*Owner Occupied and Scattered Site Rehabilitation Programs*

**Addendum # 3  
November 24<sup>th</sup>, 2017**

Project # 5057 Property Address: 33 Blair Street, Milford, CT

Drawing Sheet, A-1.3 – Details and Sections

DETAILS  
AND SECTIONS

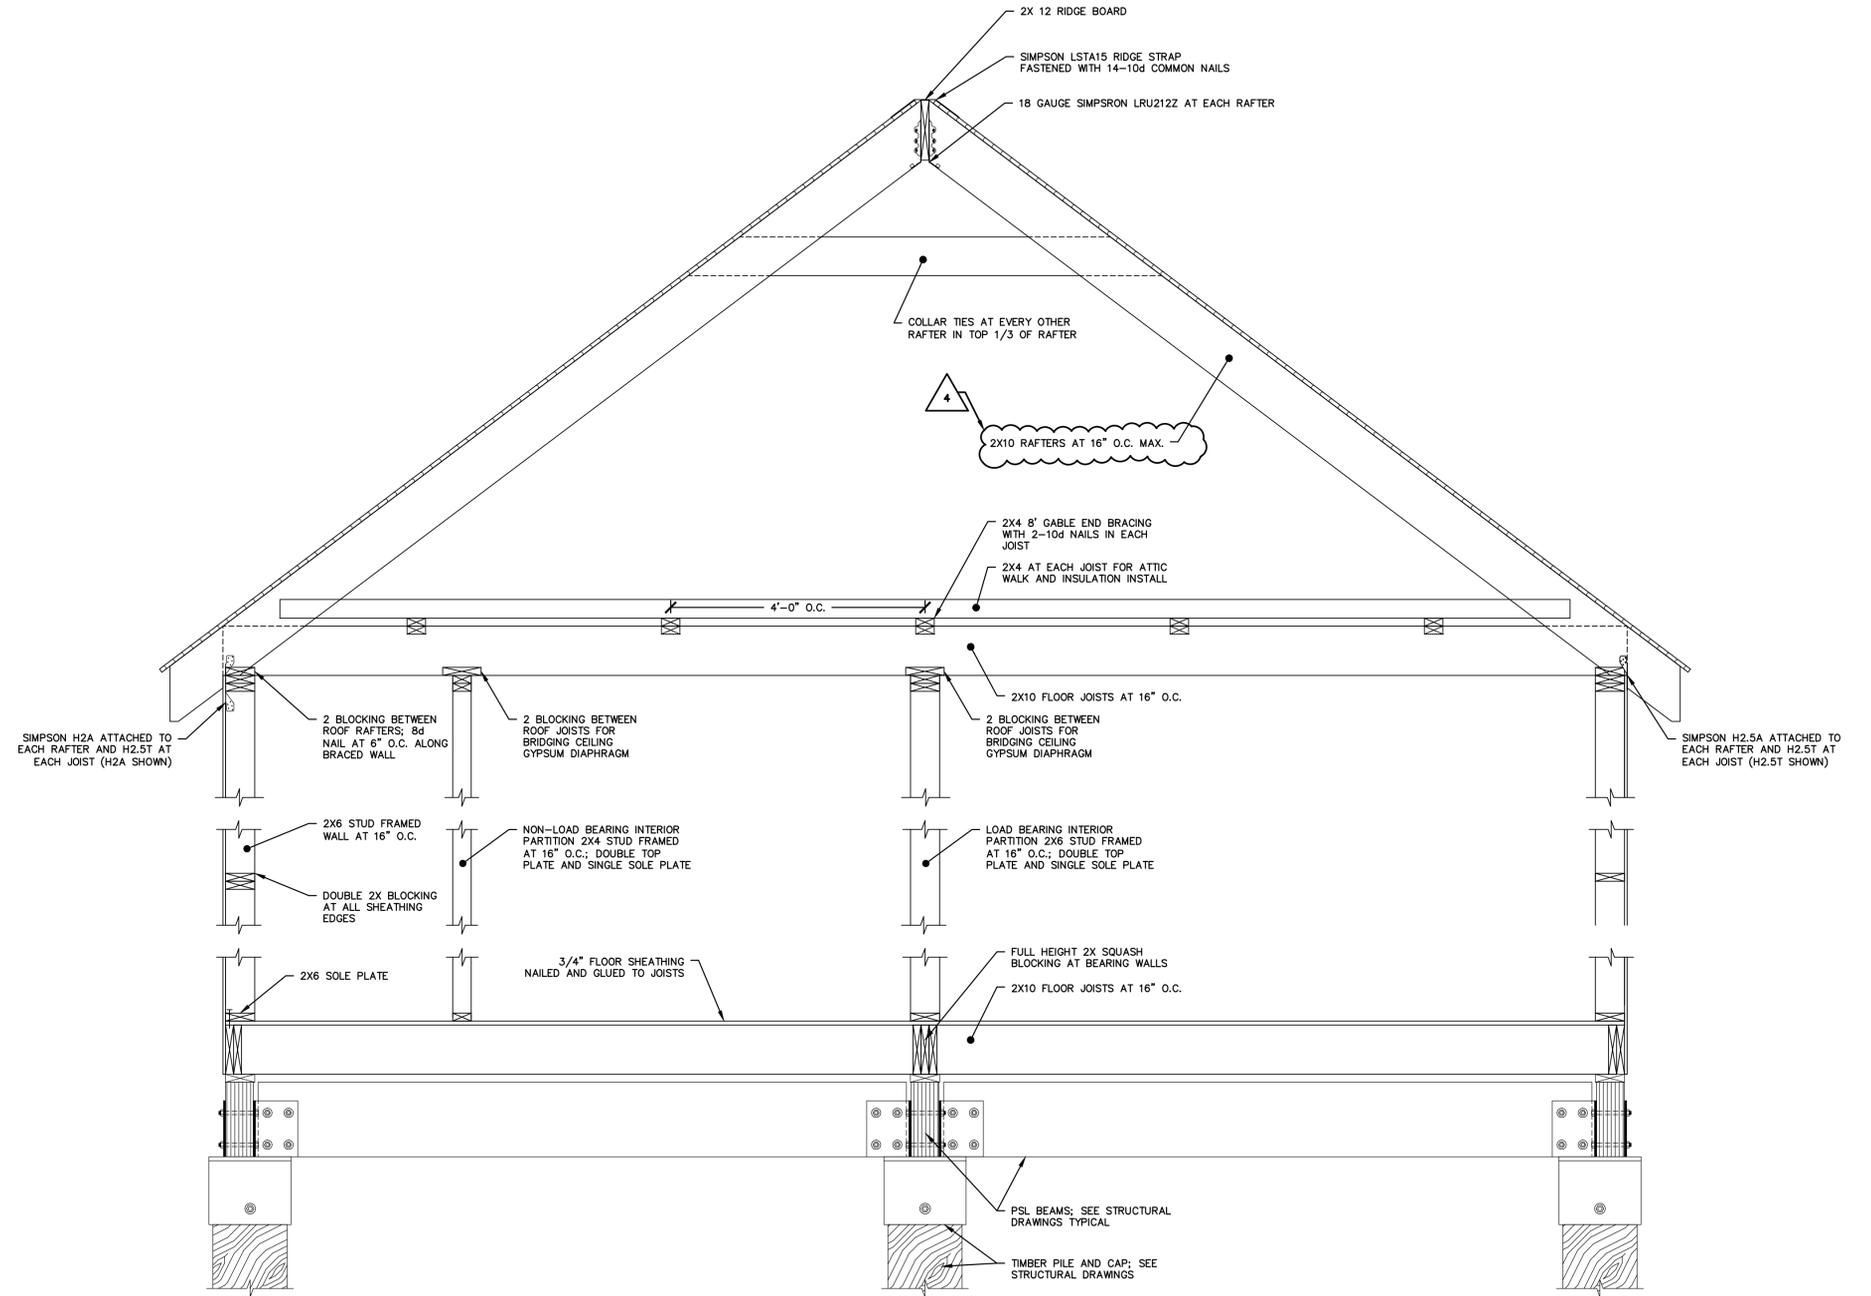
NO.	DATE	REVISIONS	BY	CHK	APPV
4	11/22/2017	REVISE ROOF RAFTER CONSISTENT TO A-1.2/A-1.4/A-2.0	MBR	MBR	REC
3	11/07/2017	ISSUED FOR RE-BID	MBR	MBR	REC
2	8/24/2017	ISSUED FOR BID	MBR	MBR	REC
1	8/7/2017	ISSUED FOR CT DOH REVIEW AND APPROVAL	MBR	MBR	REC
